Consultant	Wahib Medanat Consultant Engineer	Rep No.	12-12012022
Contractor	Derar Saraireh & Sons for Engineering & Contracting	Tender No.	(11/2019/USAID/SKEP/3/S) Schools for a Knowledge Economy Project (SKEP) - Phase (3) Package (1, 2)
Site Name	Al Khansa' Basic Mixed School- Al Balqa	Day/ Date	Wed. 12/01/2022
Duration of Project	450 Calendar Days	Total Project Budget	9,789,417.840 JD

Visit Notes

(Figure: 21)

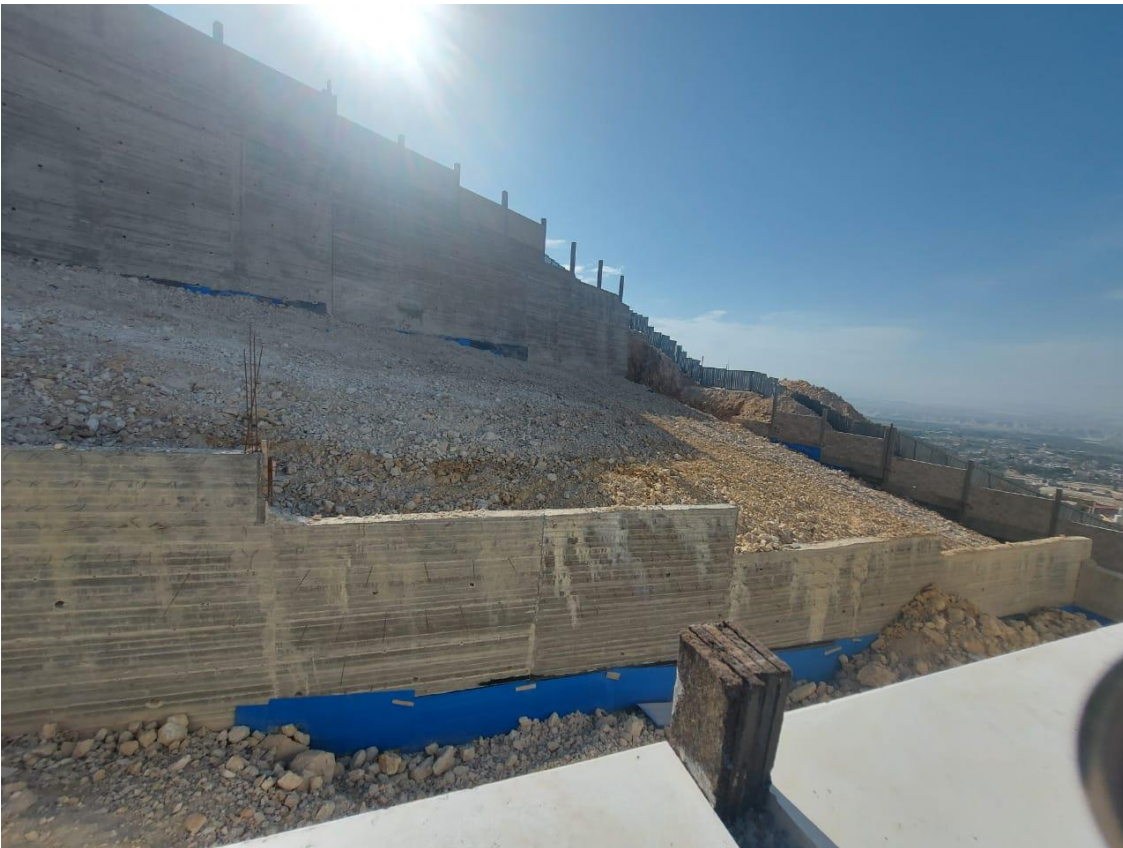
The Contractor was instructed to accelerate the work in the bases of the mechanical equipment at the roof to allow for the work of waterproofing at zone "B"
